**THE CITY OF KEY WEST
PLANNING BOARD**

Staff Report

Agenda Item: **Major Development Plan – 3201 Flagler Avenue (RE# 00052870-000100)** - A request for a major development plan approval to reconstruct a two-story mixed-use commercial and residential structure with landscape waivers on minimum landscape percentage, street frontage, interior, and perimeter landscaping on property located within the Limited Commercial (CL) Zoning District pursuant to Chapter 108, Section 108-91, and Article III through IX, Chapter 122, Article IV, Division 4, Subdivision II, and Section 122-28 of the Land Development Regulations of the Code of Ordinances of the City of Key West, Florida.

Proposed Site Plan

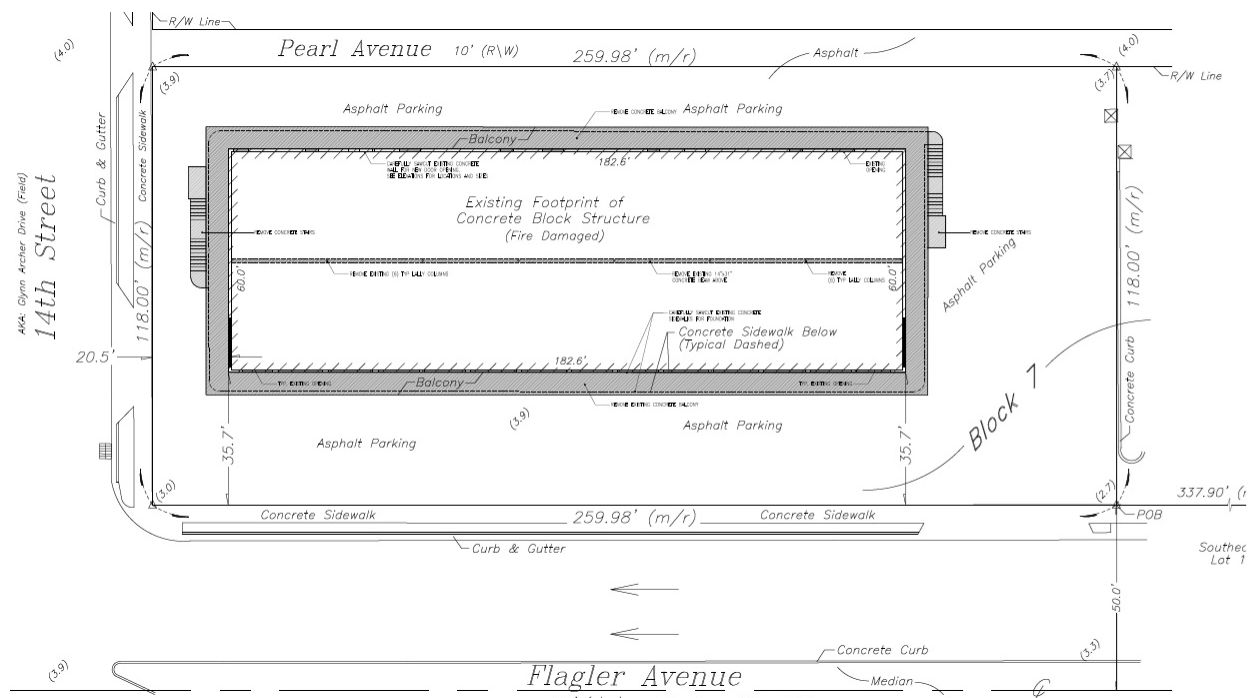
Dimensional Requirements	Required		Existing		Proposed		Complies
Max. Density	16 du/ac	11.27	14		14		N*
Max. FAR	0.8	24,541.60	0.7	21,230	0.7	21,210	Y
Max. Height	40'		30'		25'-8"		Y
Max. bldg coverage	40%	12,270.80	46.5%	14,262	46.5%	14,262.00	N*
Max. ISR	60%	18,406.20	100%	30,677	98.5%	30,222.00	N*
Front setback	25' or 20% of lot depth	25'	29'-8"		29'-8"		Y
Rear setback	25' or 20% of lot depth	25'	16'-2"		16'-2"		N*
Side Setback	15' or 10% of lot width up to 20' max, whichever is greater	20'	46'-1"		46'-1"		Y
Side street setback	20'		9'-8"		9'-8"		N*

*Per Sec. 122-28, structure may be replaced at its nonconforming density, location, and three-dimensional building envelope.

Code	Required	Existing	Proposed	Complies
Commercial	1 space/300sf	37			
SF Residential	1 space/unit	14			
Total		51	48	48	No*

1. The proposed development shall be consistent with the plans by WSA Architecture, dated April 11, 2025, including the site plan sheet with revision date July 29, 2025.
2. The proposed development shall be consistent with the drainage plan by Northstar Engineering LLC signed August 25, 2025.
3. Final landscape plan approval is required from the Tree Commission or the Urban Forestry Manager prior to City Commission.

Proposed Landscape & Drainage Plan

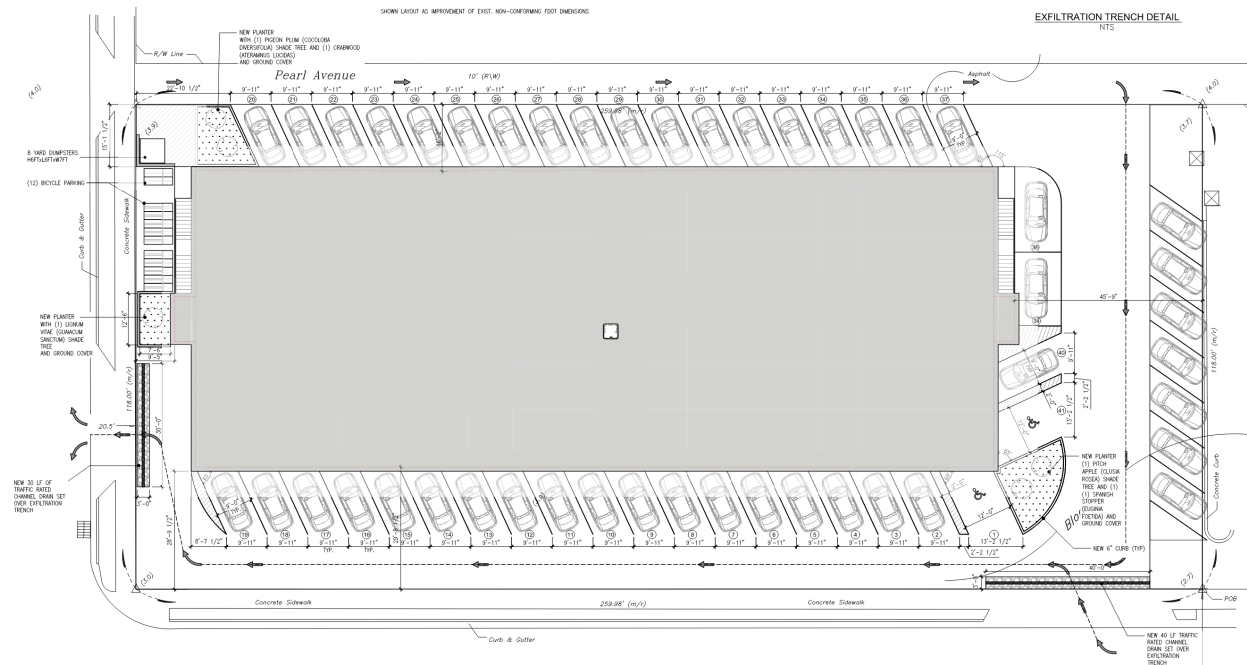
access/egress considerations. / Sec. 108-318. - Separation of vehicles, bicycles and pedestrians.		
Article V: Open Space, Screening & Buffers		
Sec. 108-346. - Open space, landscaping and removal of exotic vegetation.	The applicant proposes landscaping improvements with approximately 450 sq. ft. of new landscaping where none exists currently.	Build-back permitted per Sec. 122-28.
Sec. 108-352. - Reducing landscape and/or bufferyard requirements.	30' required street frontage landscape buffer.	Build-back permitted per Sec. 122-28.
Article VI: Landscaping		
Sec. 108-411. - Landscape plan approval.	The conceptual landscape plan was reviewed and approved by the Tree Commission on August 19, 2025.	Yes.
Sec. 108-413. - Requirements along street frontage.	The site requires a landscape strip along the frontage at least 30' in width, with at least 120 plant units per 100 linear feet.	Build-back permitted per Sec. 122-28.

Sec. 108-416. - Other landscape requirements for nonvehicular use areas.	The site requires 4 trees for every 2,000 sq. ft. of nonvehicular open space.	Build-back permitted per Sec. 122-28.
Sec. 108-452. - Required sight distances for landscaping adjacent to public rights-of-way and points of access.	N/A	N/A
Sec. 108-481. - Specifications for plant materials.	If palms are used, they shall constitute no more than 25 percent of total tree requirements	Yes.
Sec. 108-517. - Waivers or modifications.	Per Section 108-517, the Planning Board may waive or modify the standards of Chapter 108 Article VI upon a finding that the modification meets the criteria outlined in Section 108-517. Staff has reviewed the application and found it consistent with these criteria.	Yes, build-back permitted per Sec. 122-28.
Article VII: Off-Street Parking and Loading		
Sec. 108-571	No change is proposed to the existing parking configuration totaling 48 spaces.	Build-back permitted

per Sec. 122-28.
Article VIII: Stormwater and Surface Water Management		
Sec. 108-777. - Water quality criteria. & Sec. 108-778. - Water quantity criteria.	The applicant shall comply with all stormwater and surface water management criteria of the Code of Ordinances.	Yes.
Article IX: Utilities		
Sec. 108-956. - Potable water and wastewater.	Applicant has sufficient access to potable water and wastewater disposal system.	Yes.
